**Item 8.****Development Application: 433-435 Kent Street, Sydney**

File No.: D/2019/216

**Summary Recommendation:** This proposal is recommended for refusal.

**Figure 3:** Subject site and proposed rooftop terrace, viewed from Kent Street facing north.

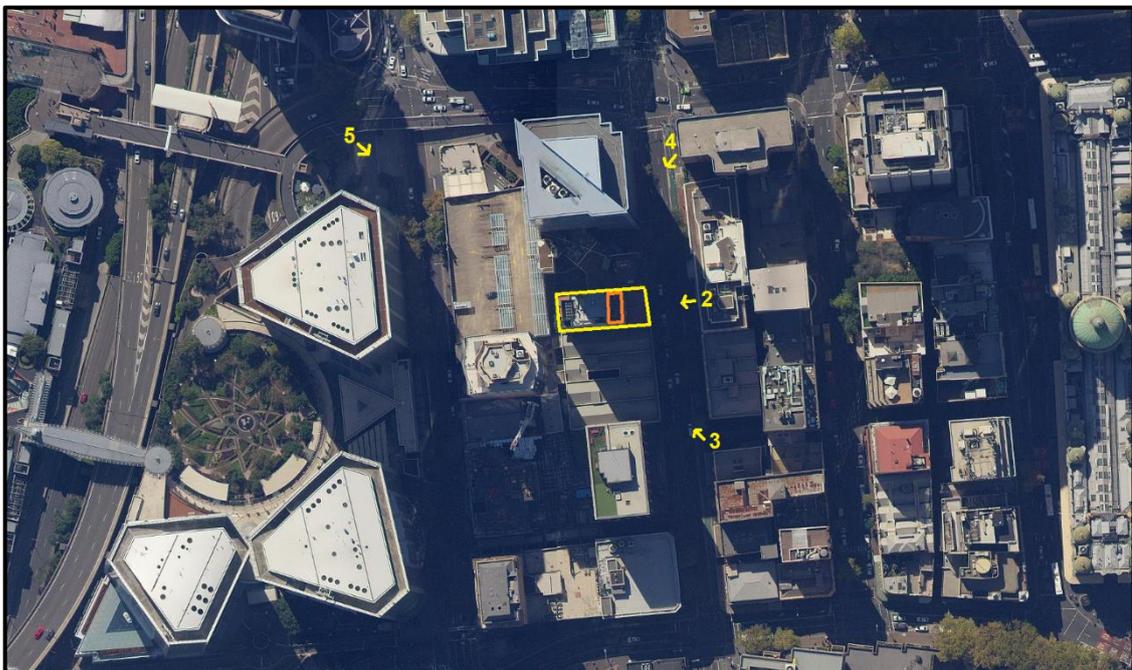
28. The existing facade is proposed to be altered and would be viewed from the public realm, contrary to the statements made in the applicant's submission.

32. The proposed addition would result in dark tinted glazing sitting flush with the masonry frame, incongruent with the remainder of the building and undermining the original design intent to have a recessive upper level framed in masonry.
33. The pergola structure proposed to sit above the addition is also non-symmetrical with the existing building, which would create a visual outcome of poor quality.
